Albrecht Motor Bike Headset Connection Cable Assembly

BHS 300 U

version with "Blue" ring as marking

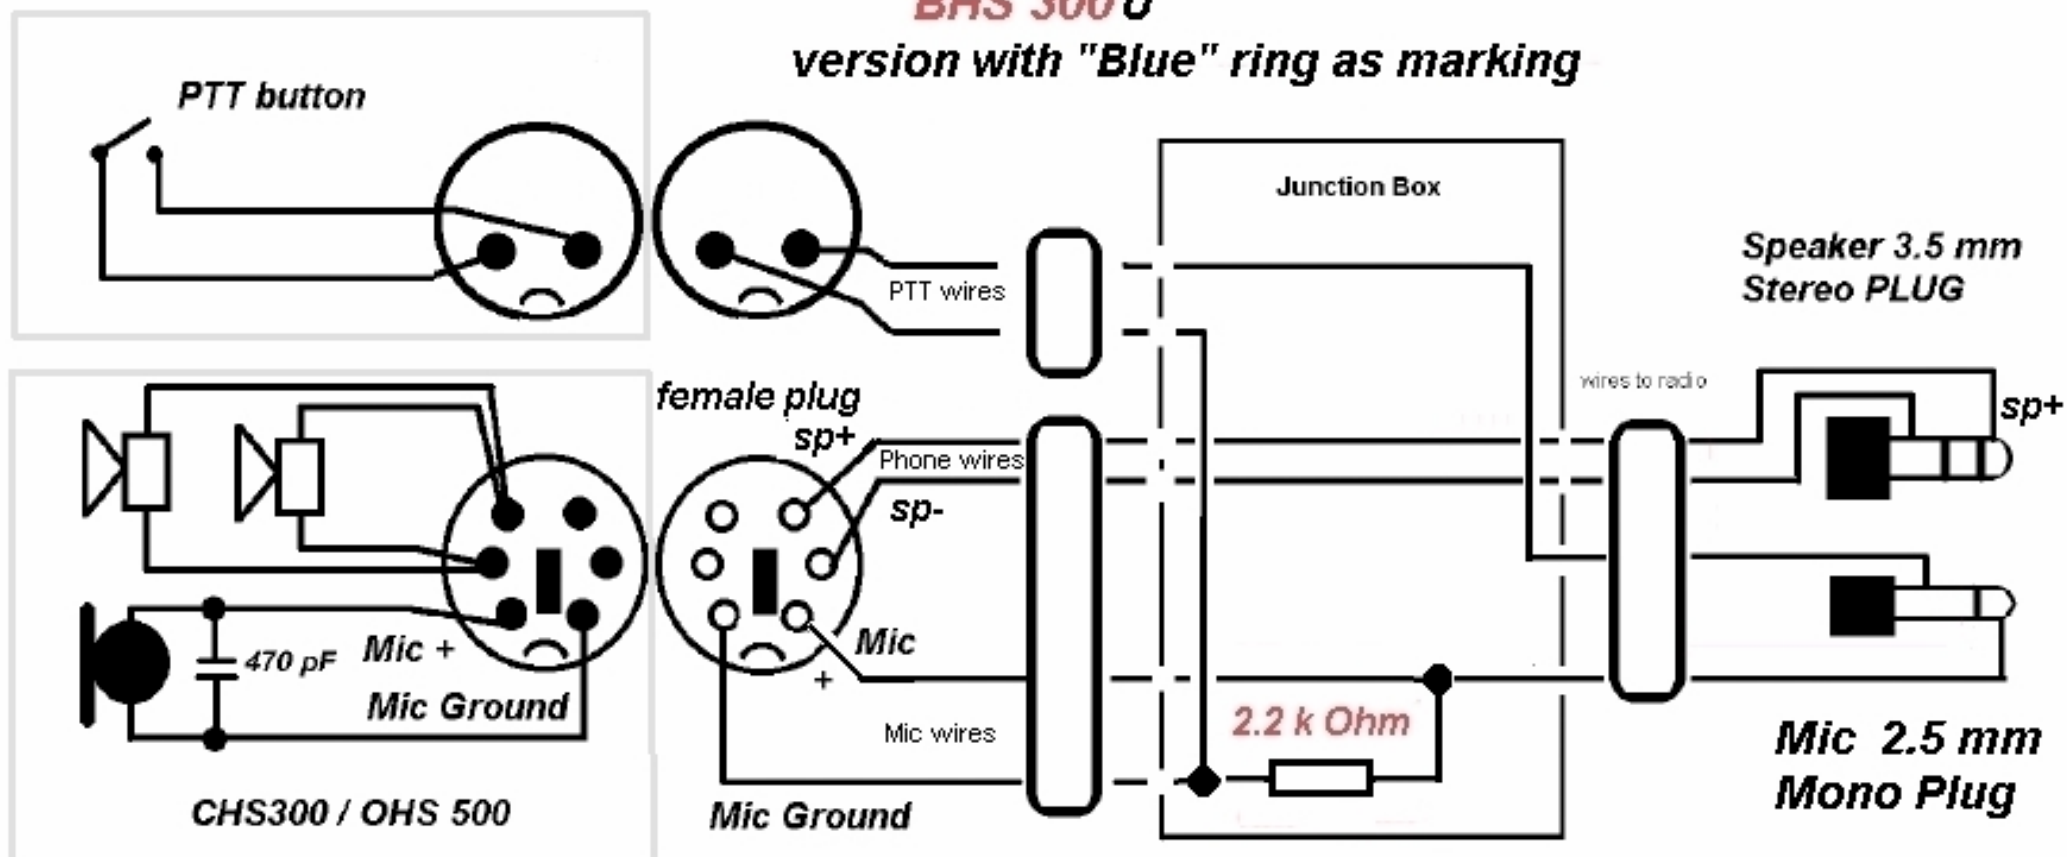
Difference to "reworked" BHS 300 U:

Speaker wires different connected to 3.5 mm plug

Blue Ring to distinguish from BHS 300 N
